Reliability Analysis Update

Hamad Ahmed
Sub Regional RTEP Committee - PJM West
December 12, 2023

B3710 Cancellation: AA2-161 to Yukon ckt 1 and 2 138 kV

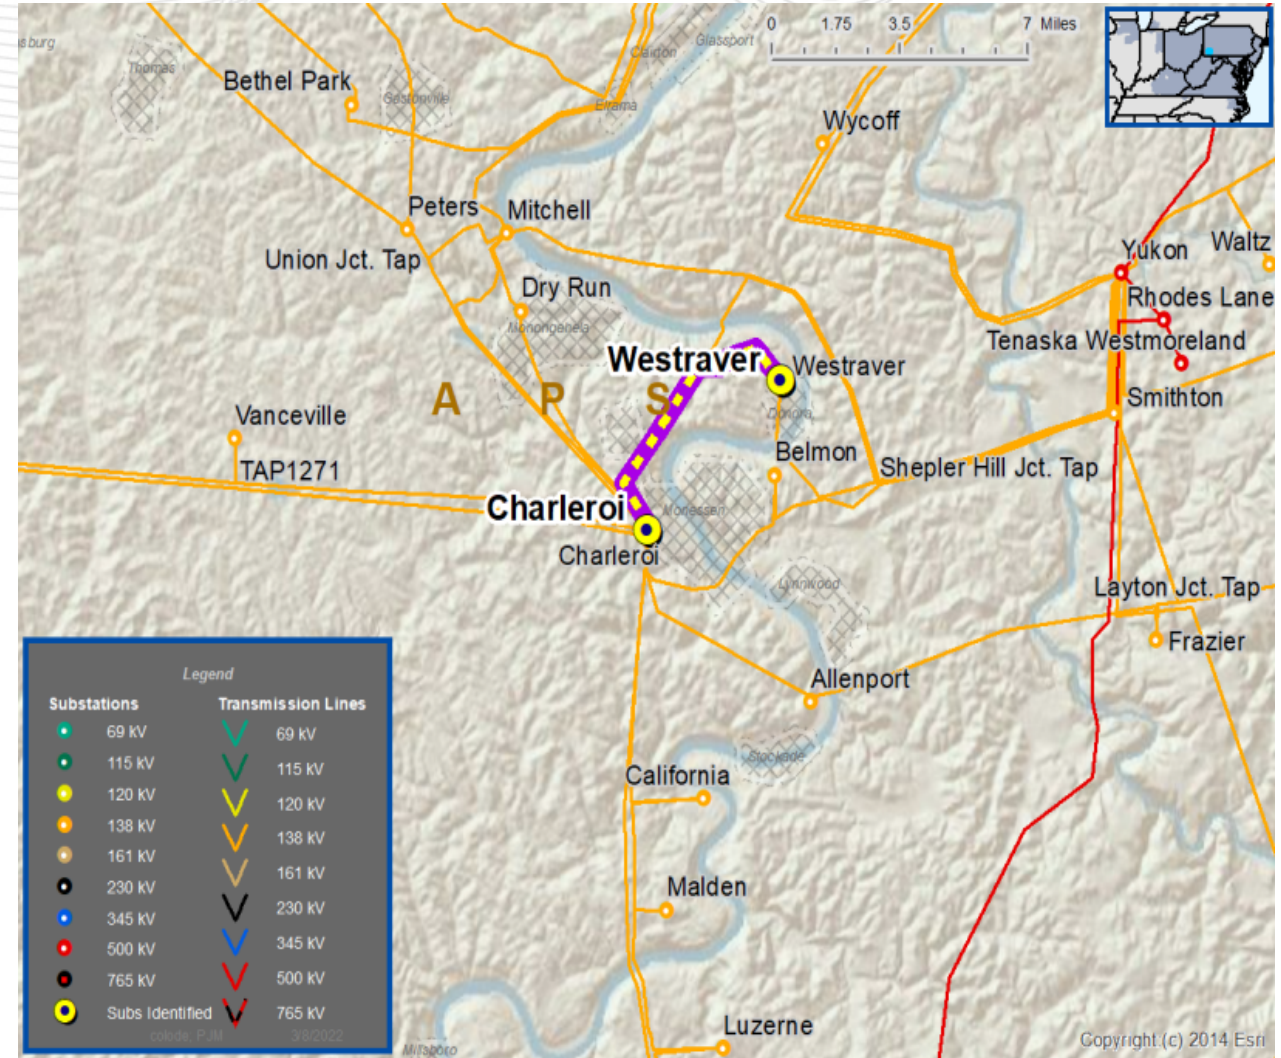
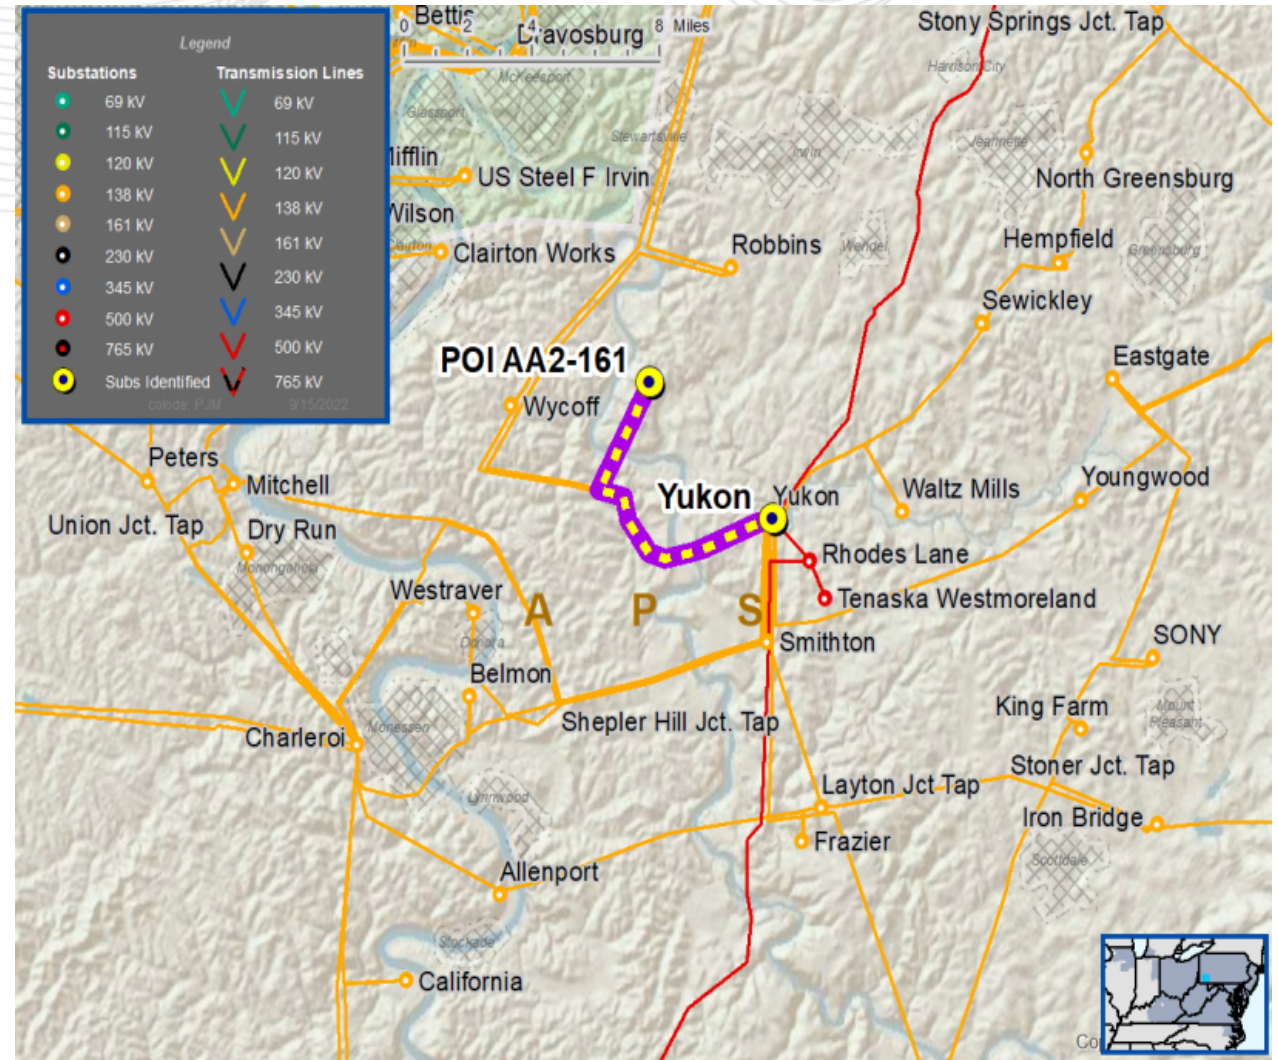
In 2026 RTEP Summer case, Yukon to AA2-161 Tap 138 kV lines are overloaded due to single contingencies.

Reason for Cancellation:

PJM IPP project AA2-161 withdrew on 10/17/2023. As a result, the baseline is no longer needed.

Reconductor AA2-161 to Yukon 138 kV lines ckt 1 and 2 with 954 ACSS conductor.
